TECHNICAL NOTE			
from:	ALAN DAVIES	date:	28/3/2022
subject:	Land at the North of the Chapel Hill site Longridge for the erection of 4no. commercial units (Use Class E).	file ref:	J1354-TN1

This Technical Note sets out the response to the feedback.

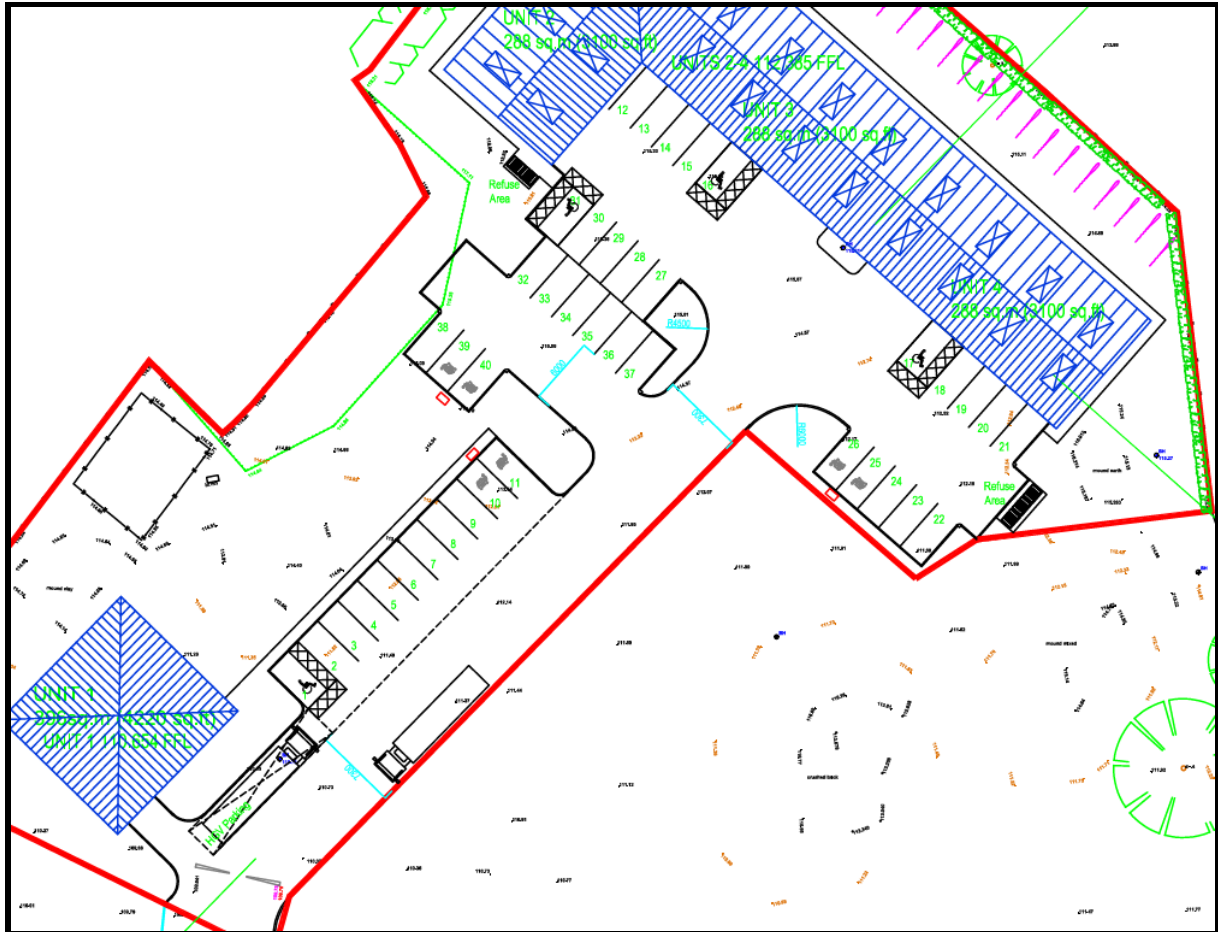
The LHA have reviewed IP drawing number 3 Rev B titled "Plans and Elevations As Proposed" and are aware that the site will provide 30 car parking spaces for the proposal. This however does not comply with the parking standards found in the Joint Lancashire Structure Plan, which requires a B1 development in Longridge with the internal floor area of 1256 square metres (sqm) to provide 40 car parking spaces.

It is worth noting that the LHA are aware that the site is in close proximity to bus stops which serve services to Preston and the Longridge area. However, should visitors to the site travel from outside these areas, the most likely mode of travel is by vehicle leading to the need for further car parking spaces to serve the site. Therefore, the LHA require the additional 10 spaces to enable the site to comply with the LHAs guidance. This should be shown on a revised plan.

The parking offered was based on location an operational needs of the site which is based on the national policy framework, the increase to 40 to meet the maximum

policy levels ignores this however the extra 10 spaces are shown on the revised drawings and the abstract below.

Spaces 37 to 40 will be designed as overspill spaces i.e. crushed stone construction to be used if and when needed.

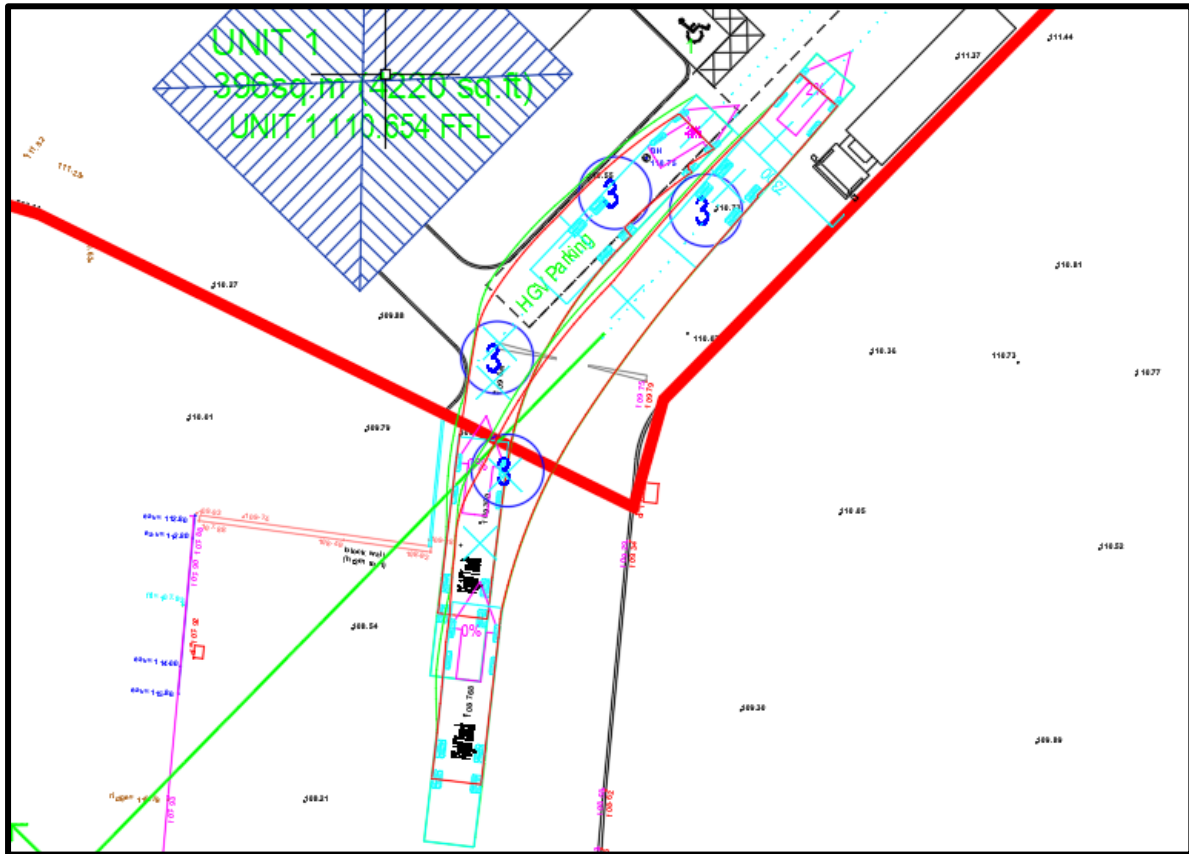
The LHA also require on the revised plan a loading area for Unit 1. This is because currently there is no area for servicing for Unit 1 and so the LHA are concerned that any servicing vehicles will block the use of the internal road into and out the site. The LHA advise that the area should be located adjacent to the Unit,

The dimensions of the loading area should be a minimum of 2.4m x 15m as a guide to enable Heavy Good Vehicles (HGV) to use the space but the LHA will require a tracking drawing to ensure that the proposed dimensions are adequate

The LHA require the space to be large enough for an HGV to use because there is a lack of designated areas for HGVs to park within the site. Not only this but should an HGV or another delivery vehicle be servicing one of the other units, the area can then be used as a waiting area until the vehicle exits the site.

A maximum rigid vehicle of 12m has been tracked for the revised internals, the spaces are designed to accommodate the size of vehicle and other than at unit 1 no requirement to mark out as they form the aisles etc.
